**BRADBURY PLACE TOWNHOMES**  
A PORTION OF SECTION 3, TOWNSHIP 19N, RANGE 04 E, W.M.  
CITY OF PUYALLUP, PIERCE COUNTY, WASHINGTON

SHEET TITLE: COVER SHEET AND HORIZONTAL CONTROL

PROJECT:	20-223
DWG NAME:	20-223 C
SHEET	REV.
C1	0
1 OF 28

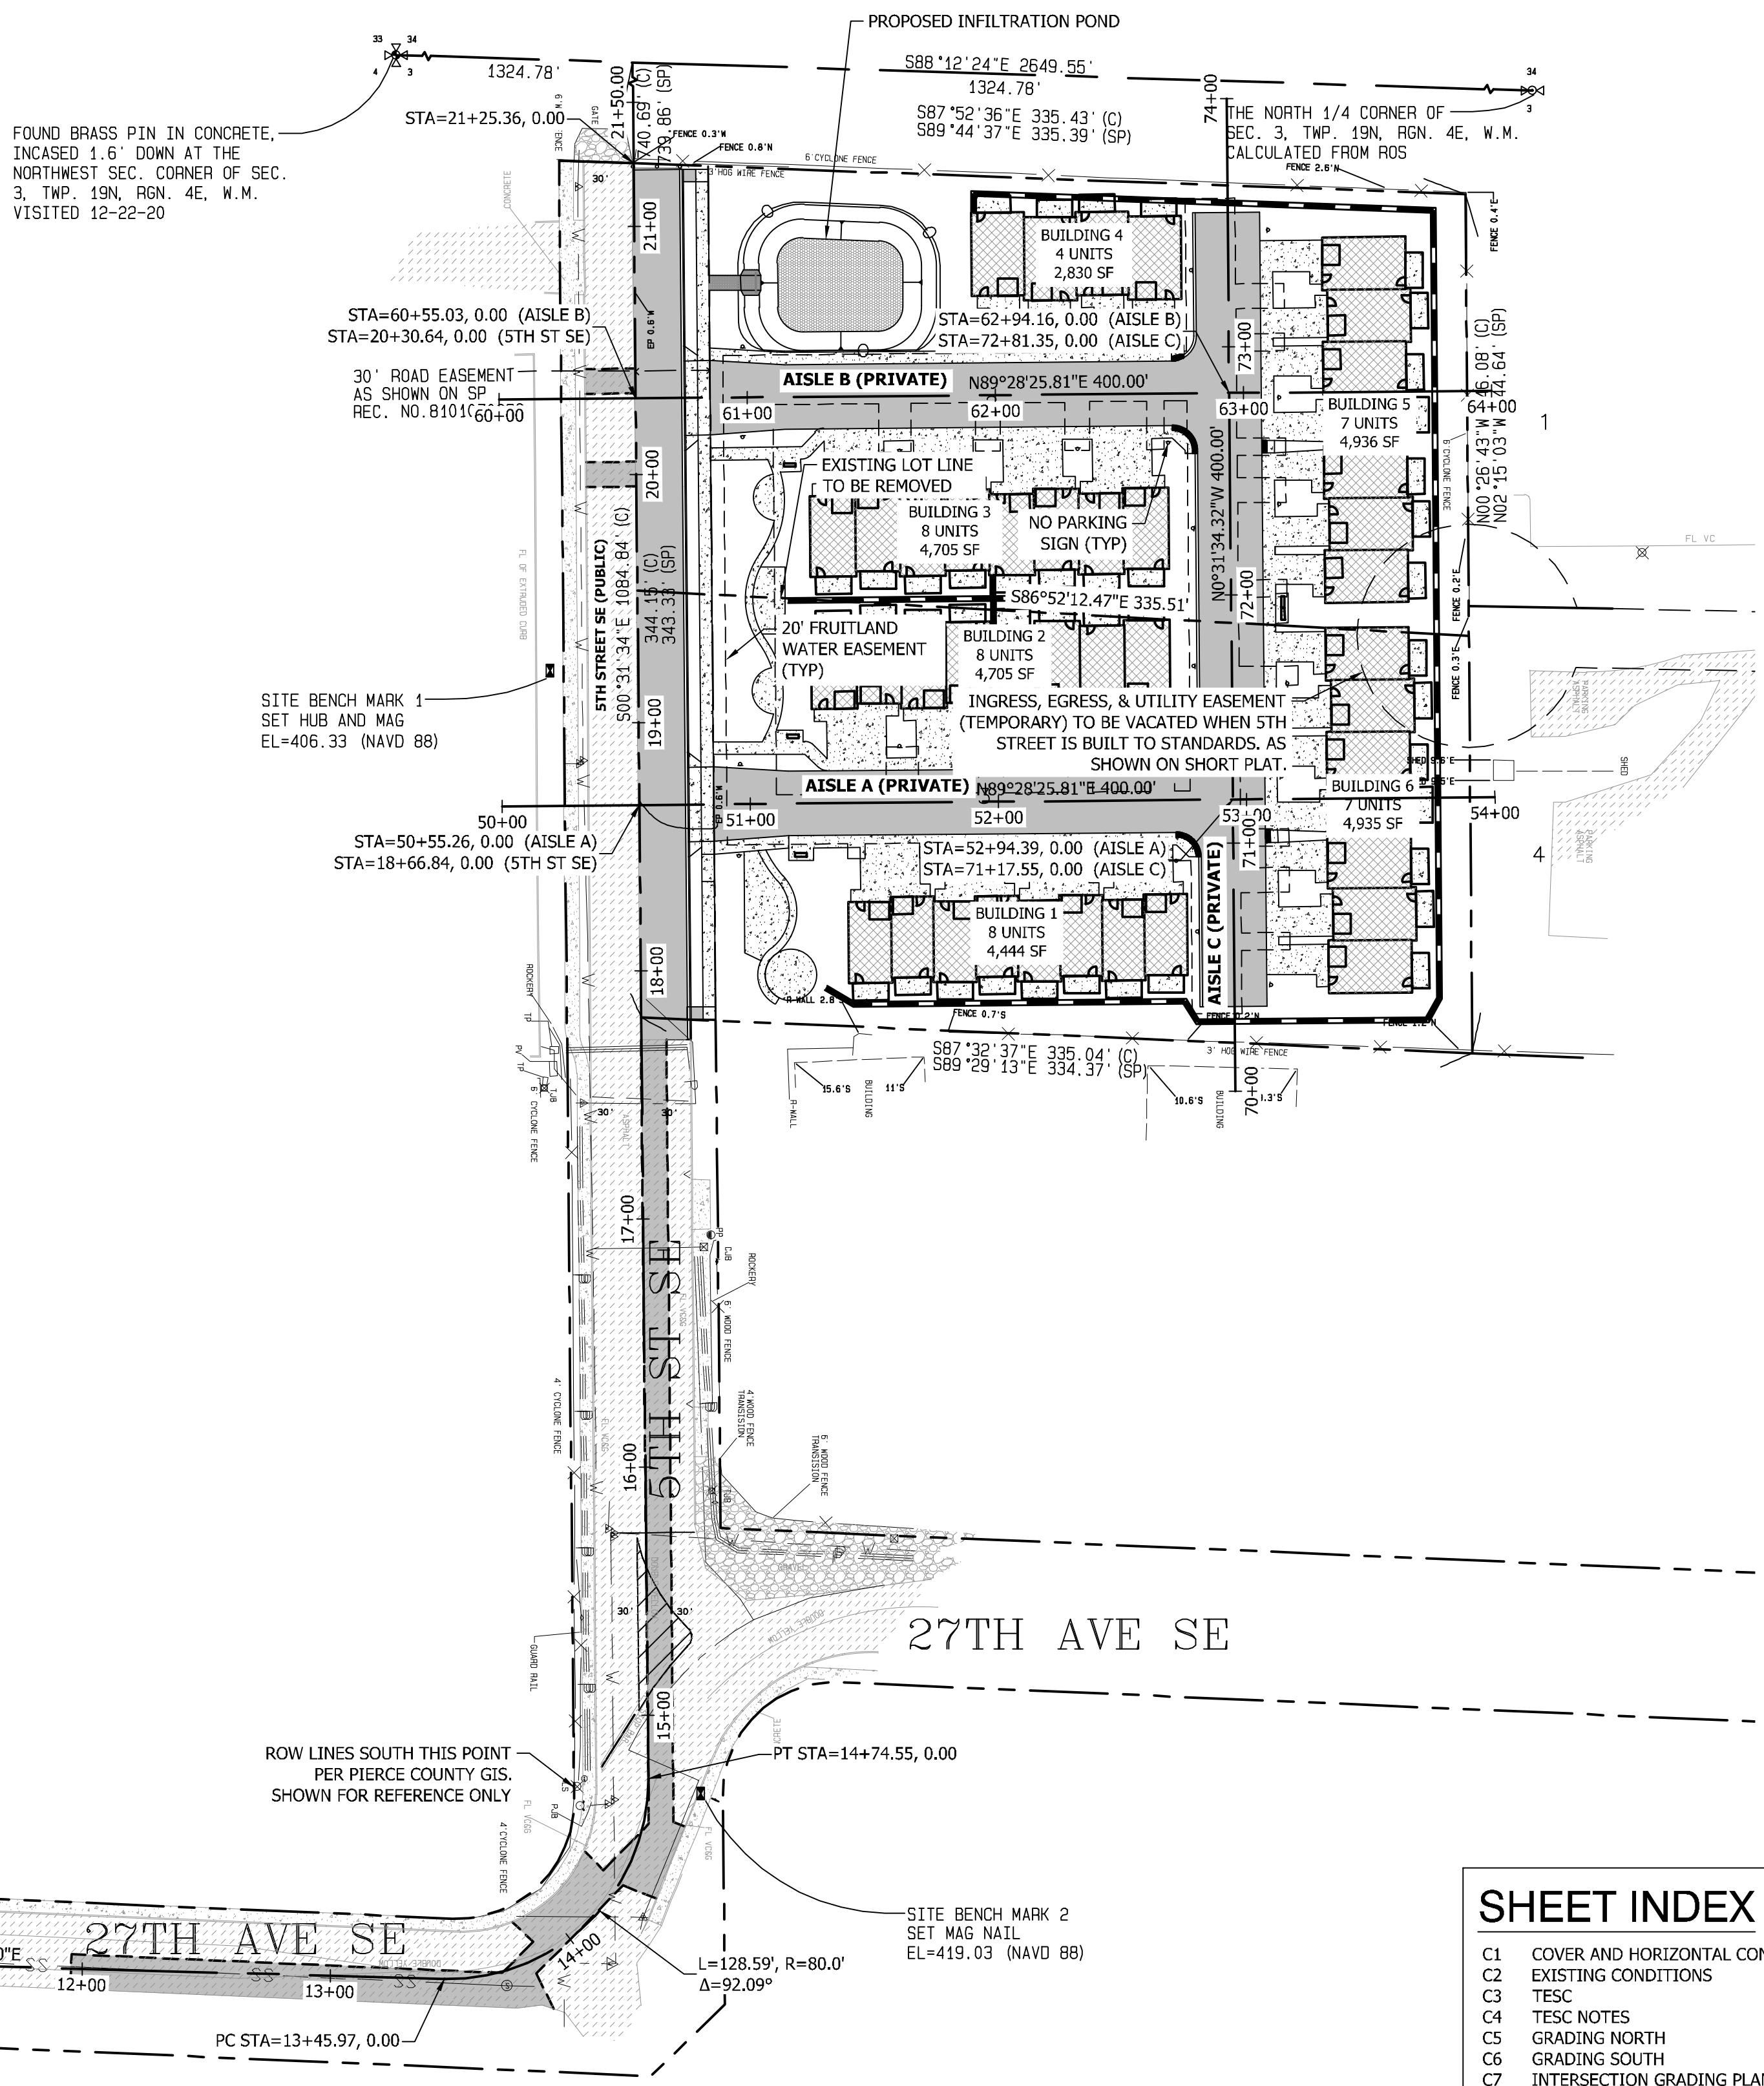
This project is served by Fruitland Mutual Water Company. The proposed water system is not being reviewed by the City, and must be reviewed and approved by Fruitland Water. Add Fruitland Water Approval Block to any plan sheets associated with water design. See City Design Standards section 1.4. [Civils, pg. 1]

SHEET TITLE: ON SITE GRADING NORTH

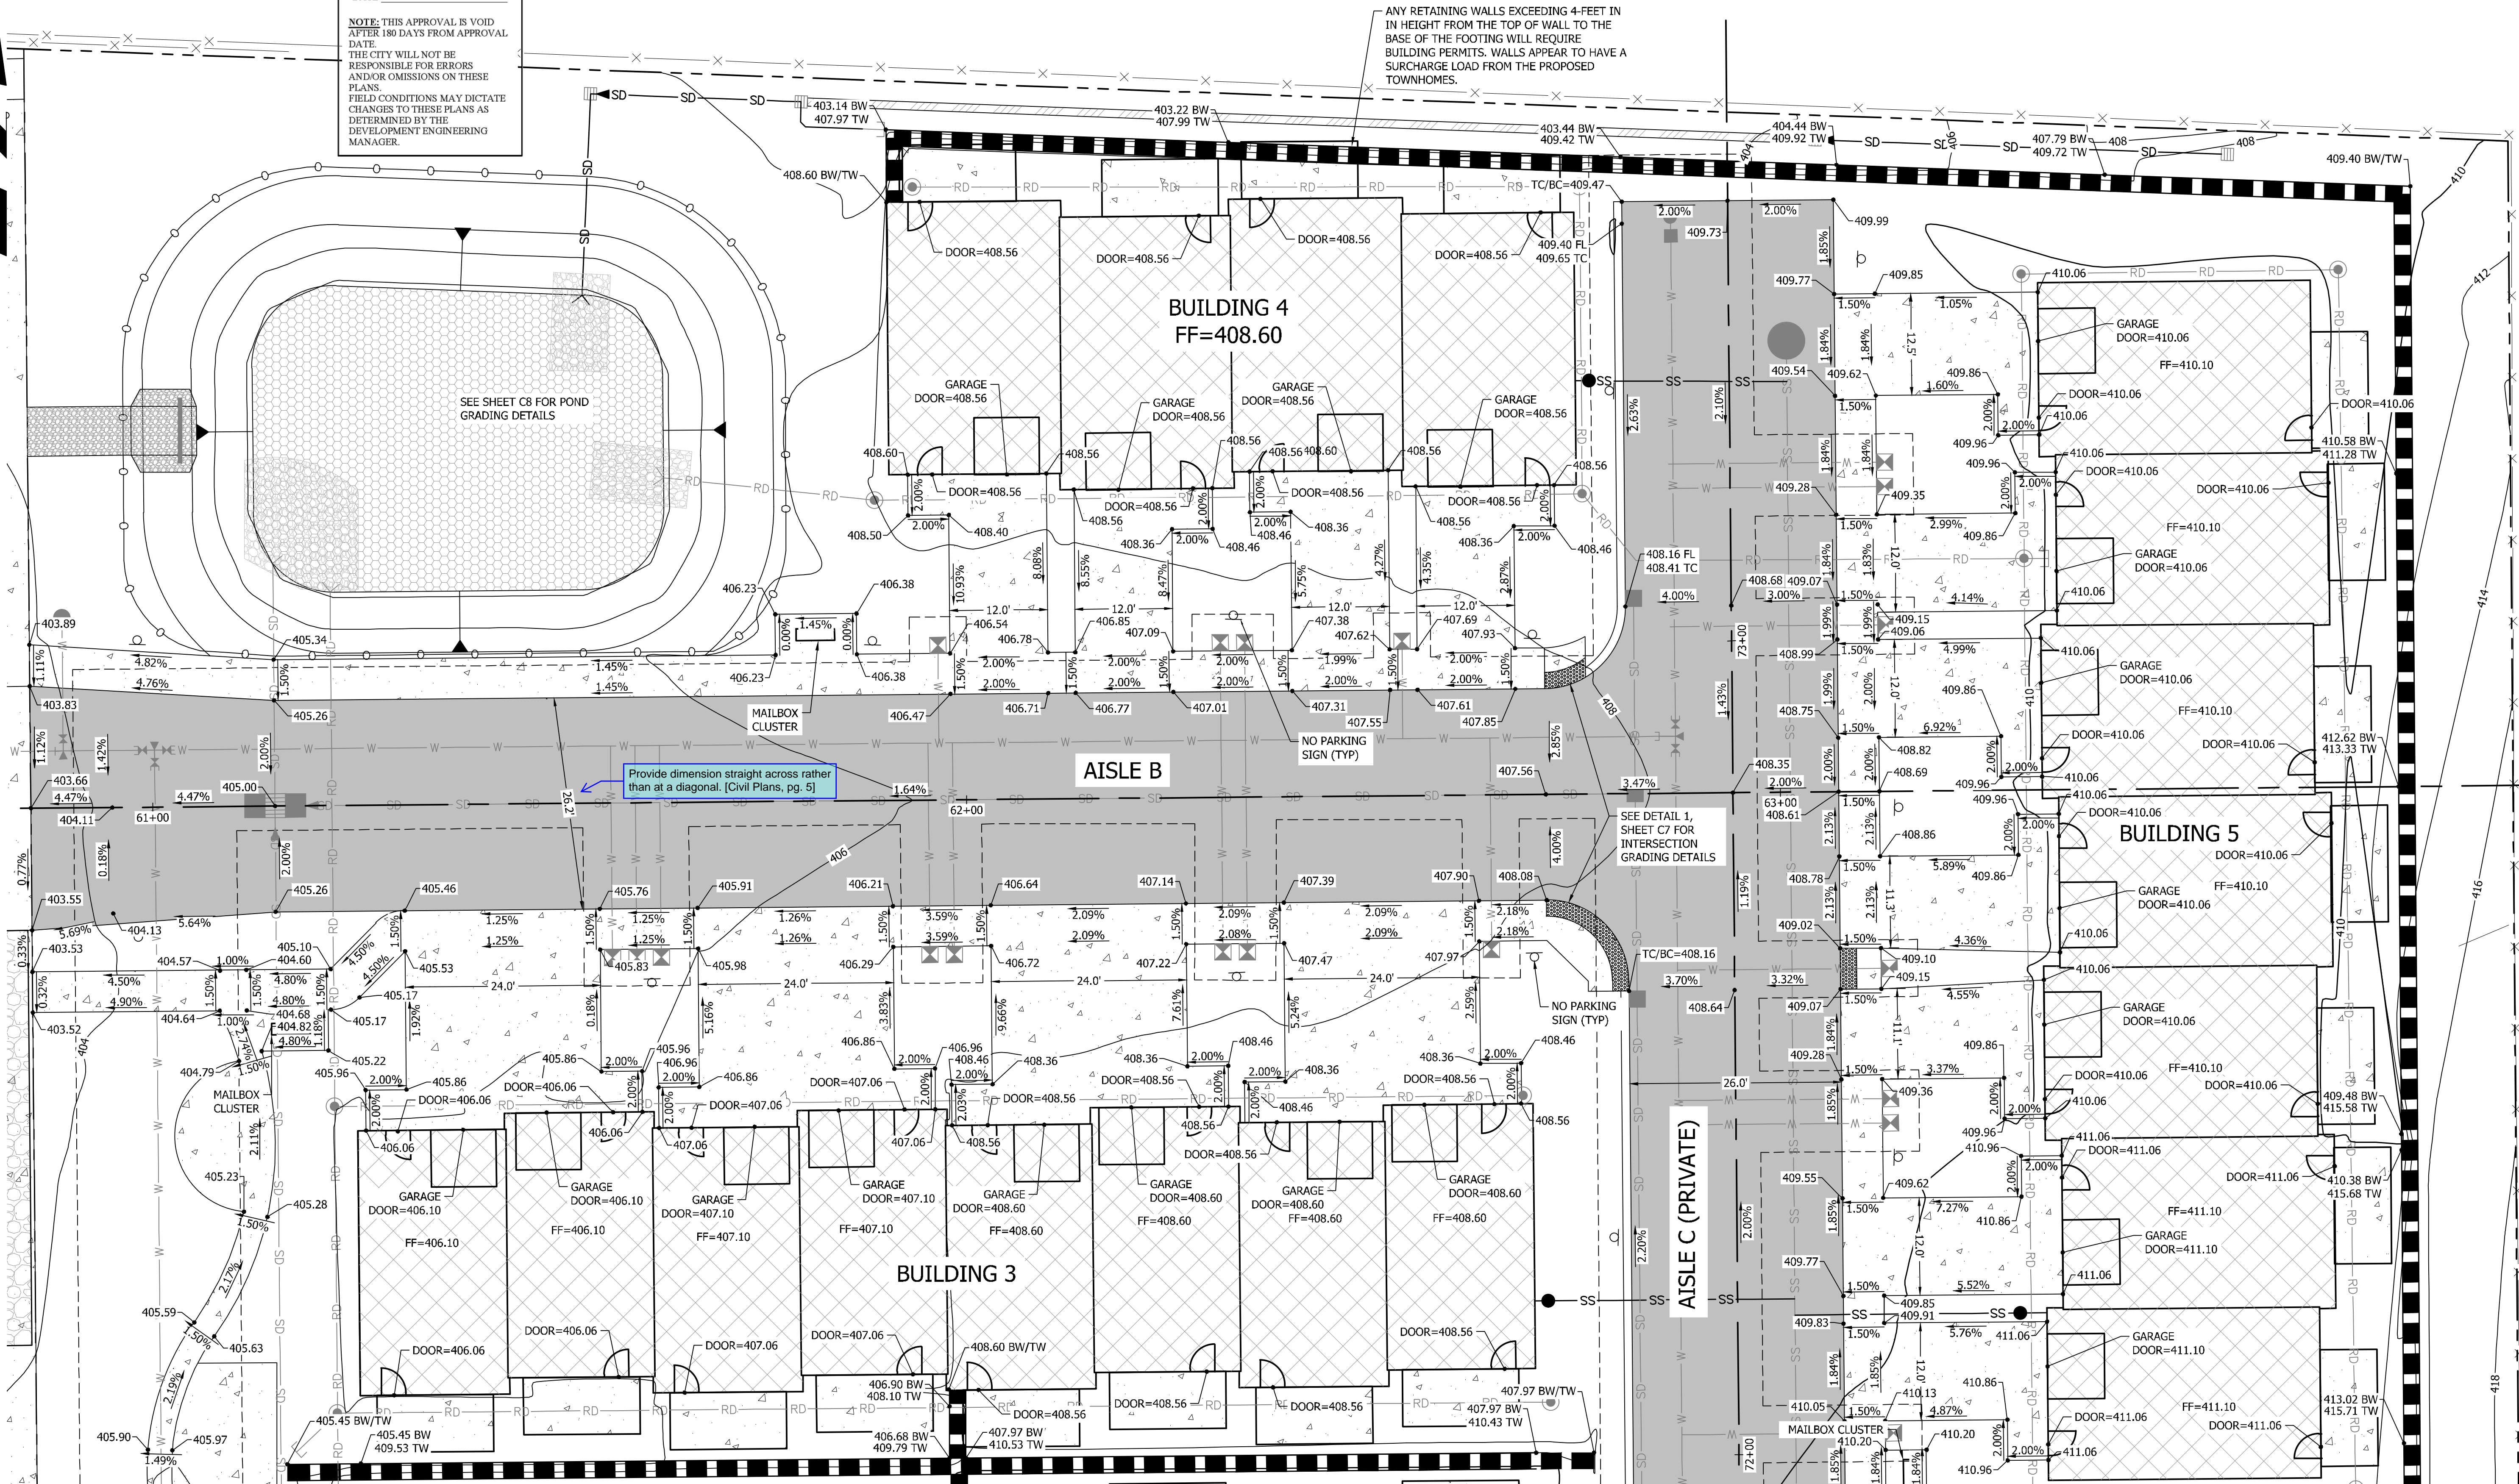
Provide dimension straight across rather than at a diagonal. [Civil Plans, pg. 5]
